Customer Notification
(CN Tracking Number: EE-QR-220724-01)
Version 1.0

Customer:	All
Renesas Product Type:	RX 100/200/600 series, 14x14 LQFP package produced at RSB China
Description of Change:	Embossed tape width change
Reason for Change:	Stable supply given by the new tape
Identification:	The change will be applied to products with production date Nov. 2022 or later shown on the upper left of the barcode on the packing label.
Schedules:	Change Implementation: Nov. 2022 (onwards)
Anticipated Impact:	Fit, Form & Function of device: No Change Quality & Reliability: No impact
Document no.	EEQC-PCN-CR-22-0156
Internal Reference:	PC-MCU-A005A/E

Details of Change:

Before change: 32 mm

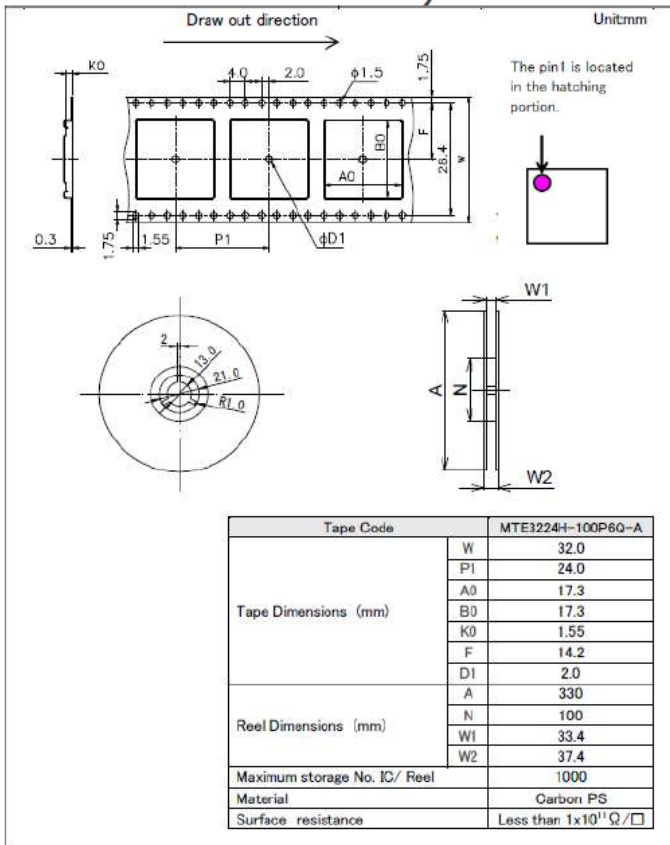
Target location (assembly and testing base): Renesas Semiconductor (Beijing) Co., Ltd (hereafter referred to as RSB) The embossed tape width was changed for the shipment of tape & reel, manufactured at RSB.

The pocket width, pocket depth, feed hole, dimension between feed hole and pocket center, reel width, and cover tape width change due to the change in tape width.

After change: 24 mm

After (W:24mm)

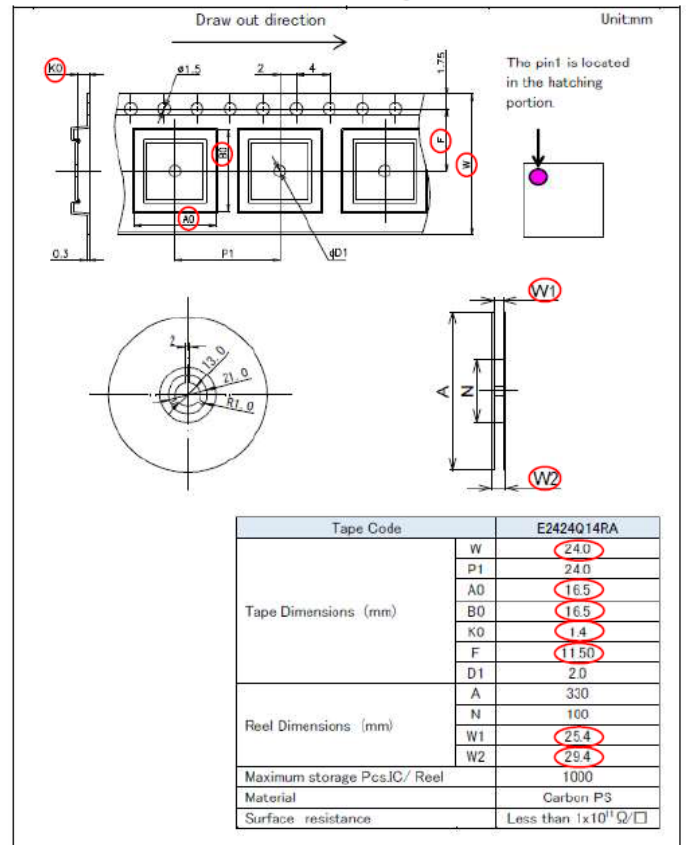
Packing material	Item	Before	After
Emboss tape	Taping code	MTE3224H-100P6Q-A	E2424Q14RA
	Sprocket hole	Both side	One side
	Tape width	32mm	24mm
	Tape thickness	0.3mm	0.3mm
	Cavity size	17.3x17.3	16.5x16.5
	Cavity depth	1.55mm	1.4mm
	Distance between cavity centers	24mm	24mm
	Material	PS	PS
Reel	Reel diameter	330mm	330mm
	Core diameter	100mm	100mm
	Reel width	For 32-mm width tape	For 24-mm width tape
